Staff Report (ID # 7557)

Summary Title: 3223 Hanover Street: Office and R&D Building

Title: PUBLIC HEARING / QUASI-JUDICIAL MATTER. 3223 Hanover Street [16PLN-00190]: Major Architectural Review to Allow the Demolition of two Existing Office / R&D Buildings and the Construction of a new two-story 110,000 Square Foot Office / R&D Building. Environmental Assessment: An Initial Study is Being Prepared Pursuant to the California Environmental Quality Act (CEQA). Zoning District: RP

Figure 1: **Original** architect's drawing, with numberings added. The traffic access ramp is at #1. An alternative entrance from the street is at #2, which would eliminate the need for the ramp at #1. (Residences are figurative.)

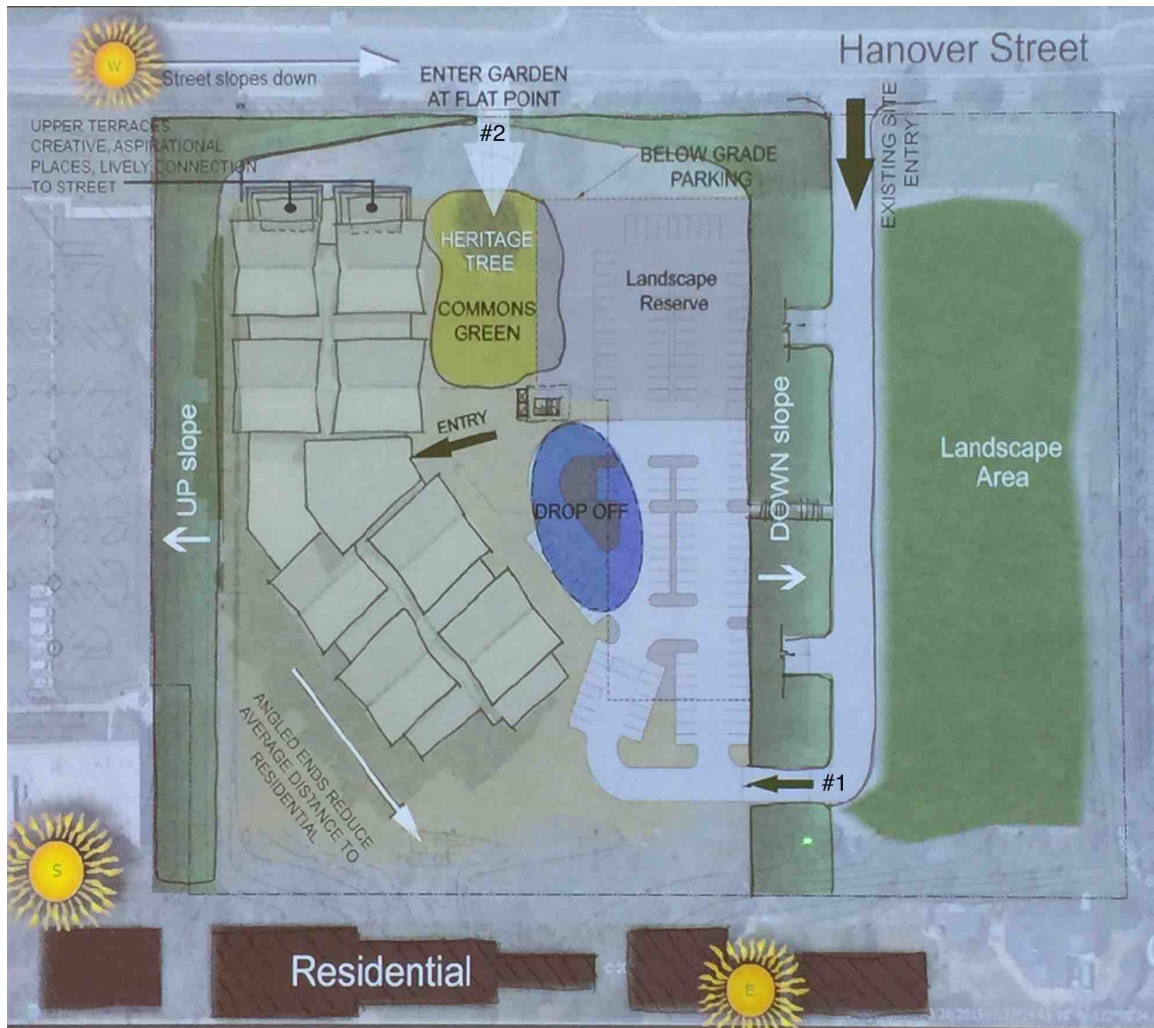
Concern 1: Our first concern was that all the traffic from the lower part of your property to the upper part of your property would be routed via a driveway ramp that is very close to the residential neighborhood. The ramp is marked as #1 on Figure 1.

In the past when Lockheed leased the property, we experienced significant car and delivery truck noise from this ramp. We asked you and Mr. Giannini if there was an alternate path to get traffic to the drop-off area in front of the buildings. We suggested several possible solutions:

1) A second entrance from the street marked as #2 in Figure 1. This would eliminate the need for the ramp at #1.

Figure 2. **Modified** drawing with alternative ramp at #3, further from the residences. (Residences are figurative.)

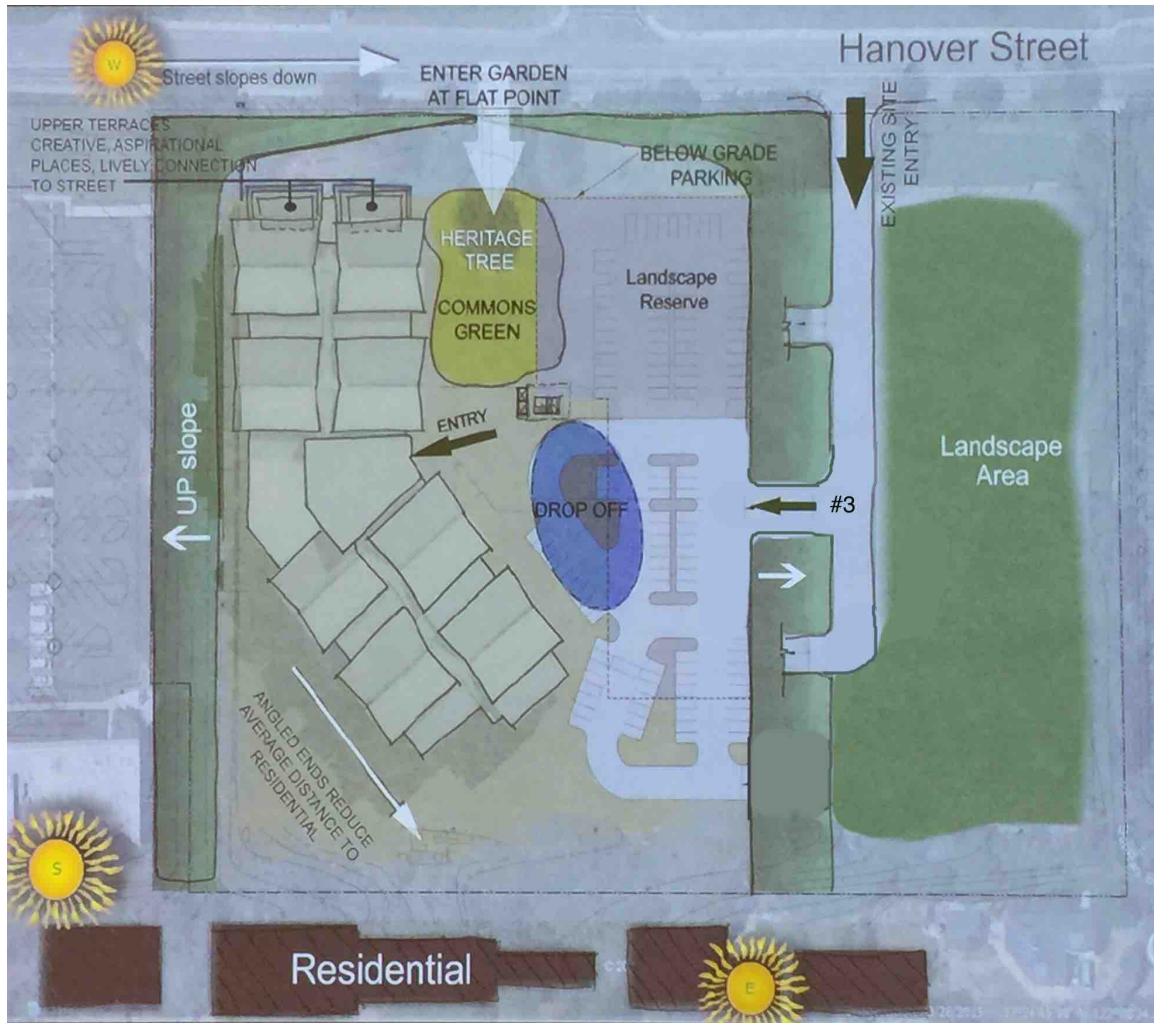
2) A ramp further from the residential neighborhood, marked as #3 in Figure 2.

Figure 3. **Modified** drawing with alternative ramp at #4, further from the residences. This ramp is diagonal in order to reduce its slope, if necessary. (Residences are figurative.)

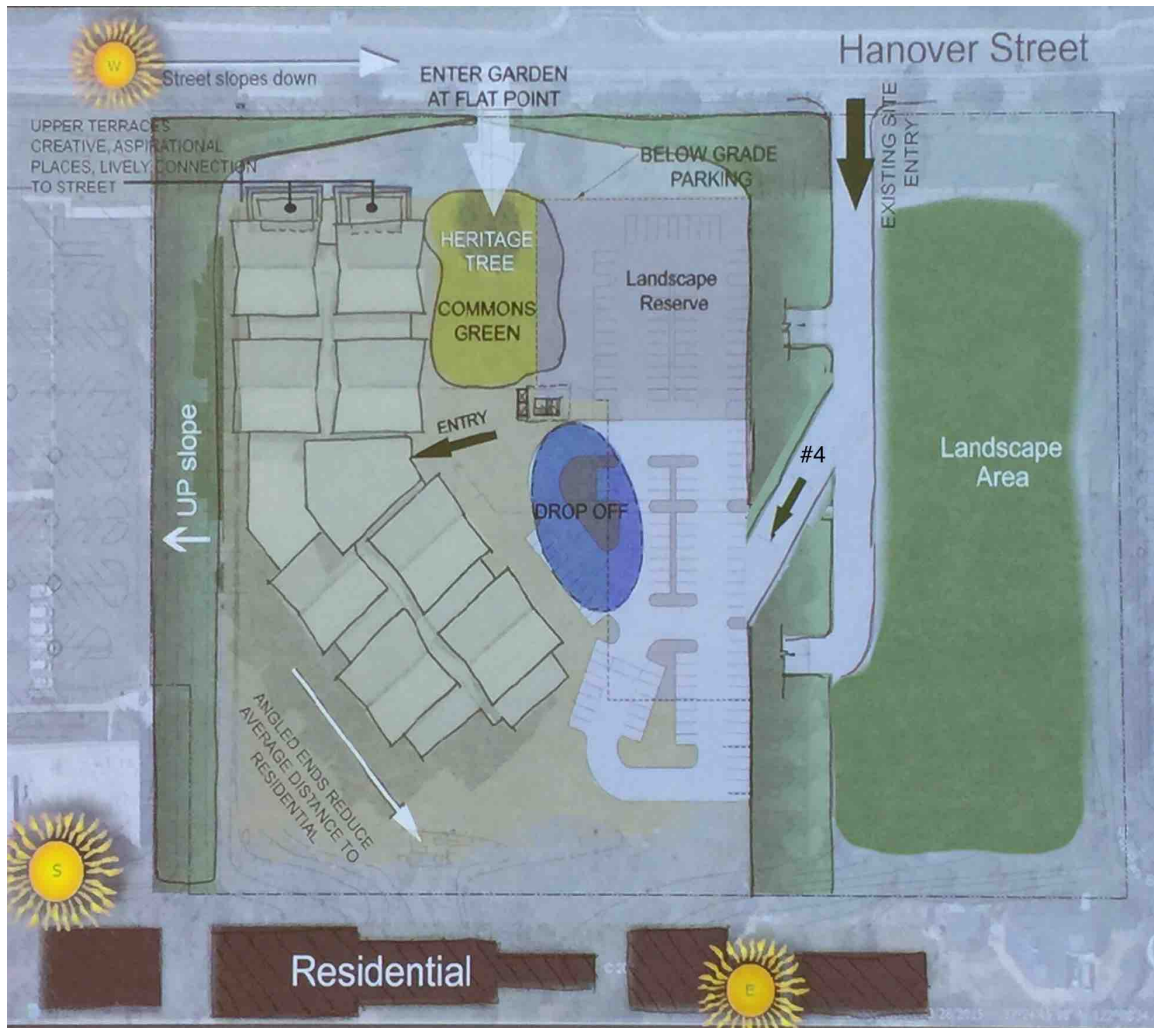
3) A ramp further from the residential neighborhood, marked as #4 in Figure 3. This ramp is diagonal to reduce its slope, if necessary.

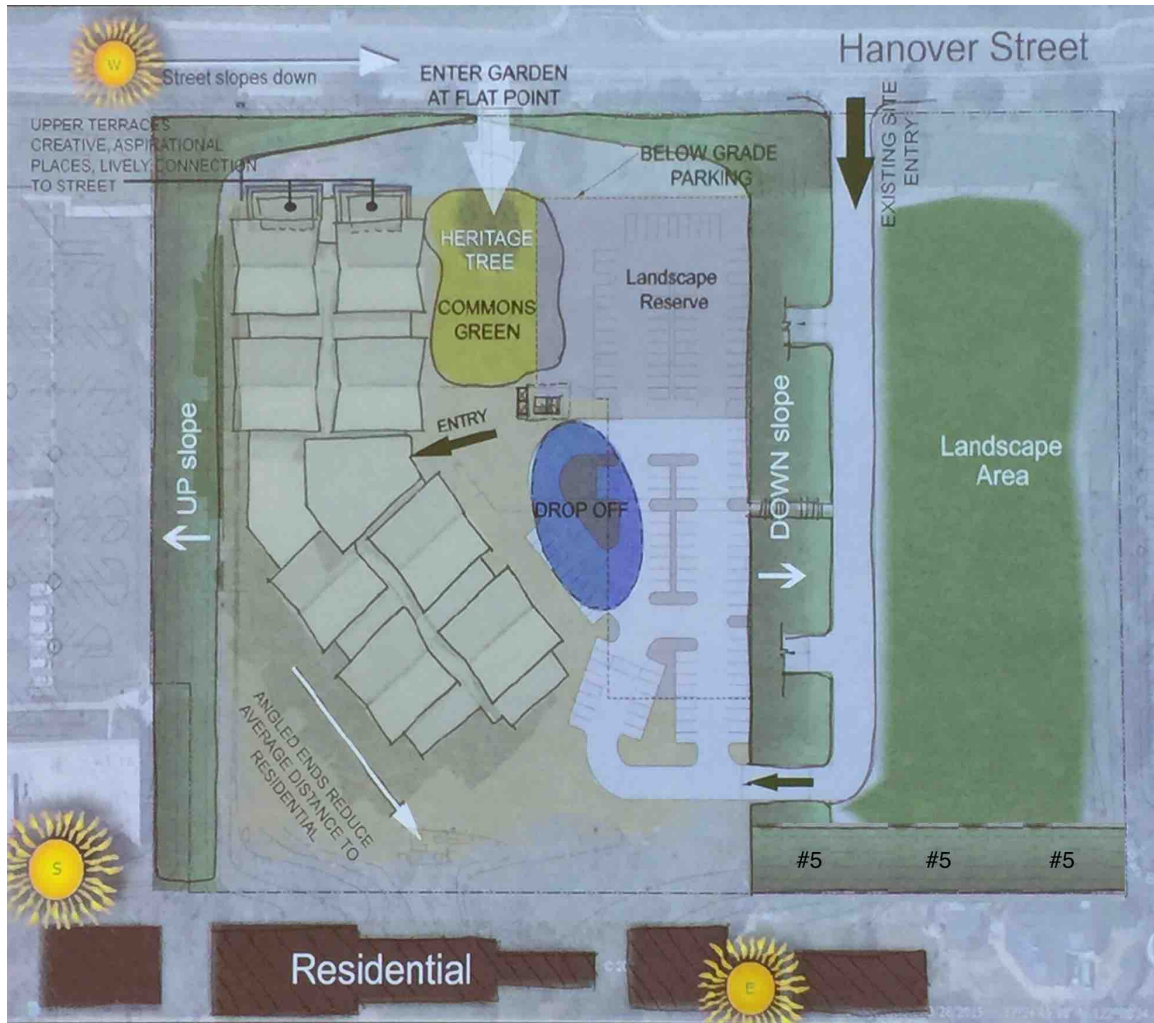
4) An earthen berm, marked as #5 in Figure 4. The SW end of this berm could start at grade level of the upper part of the property, and naturally continue at this grade level to the NE, until sloping down near the NE corner of the property. Note that at the property line near #5, the residences are currently level with the lower parking lot ("Landscape area"). This berm would also serve to block views and noise from cars currently level with the residences.

Of course, any of the above means to replace the ramp could be combined with the earthen berm implementation, to maximize the noise reduction to the residences.

Figure 5. Concerns about light emission at #6. The new buildings will be level with the second-floor bedrooms of several homes on the other side of the property line at #6.

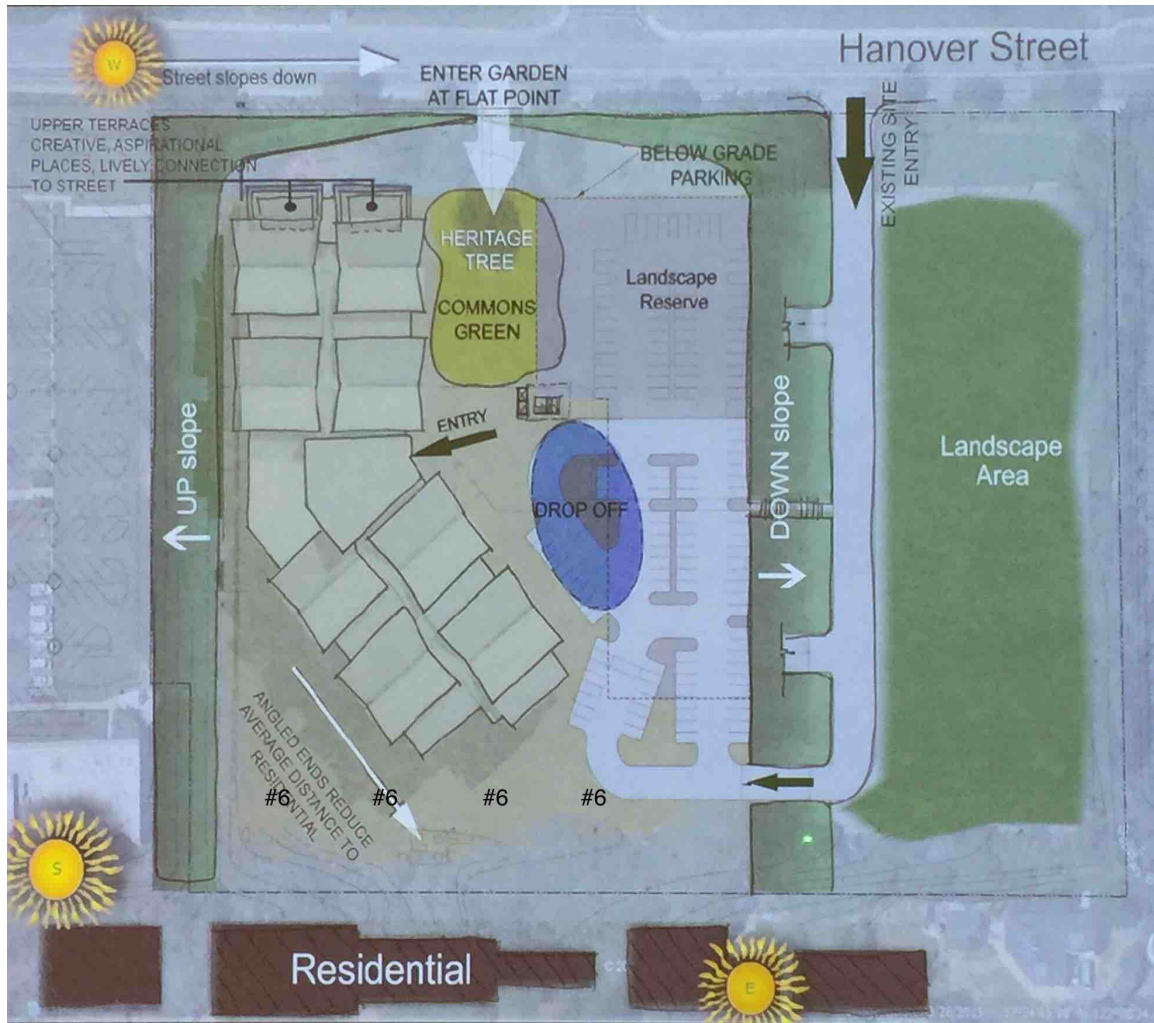
Concern 2: The second concern was light pollution from the all-glass facades of the buildings at night. The new buildings will be level with the second-floor bedrooms of several homes on the other side of the property line, as marked at #6 in Figure 5. You said you were expecting a tech industry tenant, and such companies often work late into the night.

Shielding with trees was discussed as one solution; but this is not currently effective with the outdoor security lighting you have operating on the buildings now. Reducing outdoor lighting on the residential side of the building would be more effective, but a more complete solution to reduce light pollution would involve changing the building façade. We fear that the tall, all-glass design you propose is not well-suited to coexistence with a nearby residential neighborhood.
